ADDENDUM NO. CC-1

RAYMOND CENTRAL PUBLIC SCHOOLS  
RAYMOND CENTRAL JR. & SR. HIGH SCHOOL ADDITION  
RAYMOND, NEBRASKA  
DLR GROUP PROJECT NO. 10-16113-00

COMBINED CONTRACT

August 12, 2016

# SPECIAL SYSTEMS PLAN, FIRST LEVEL - AREA A RAYMOND CENTRAL JR. & SR. HIGH SCHOOL ADDITION

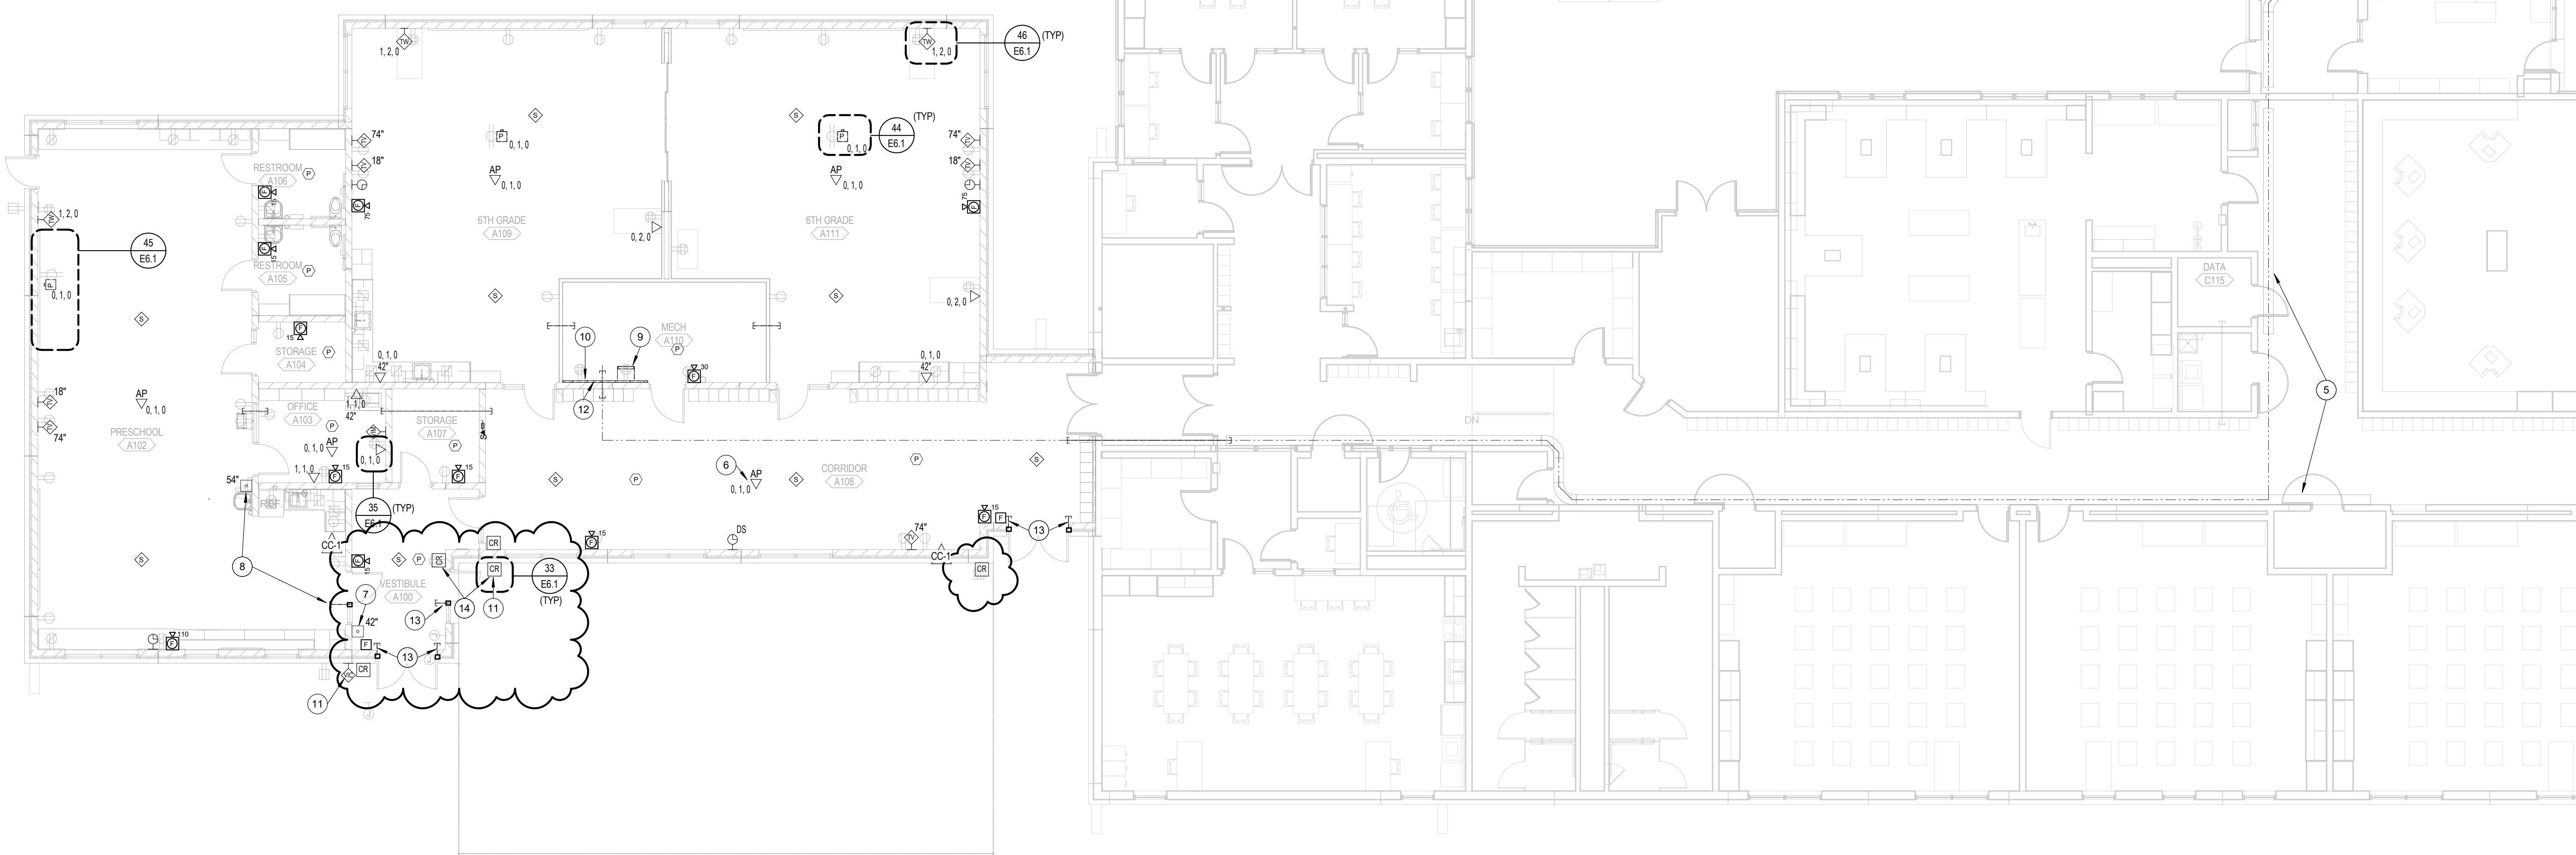
ITEM NO. 13 DRAWING E3.1 SPECIAL SYSTEMS PLAN, FIRST LEVEL – AREA A

- A. Modify Drawing as shown on attachment E3.1-1 dated 08-12-2016.
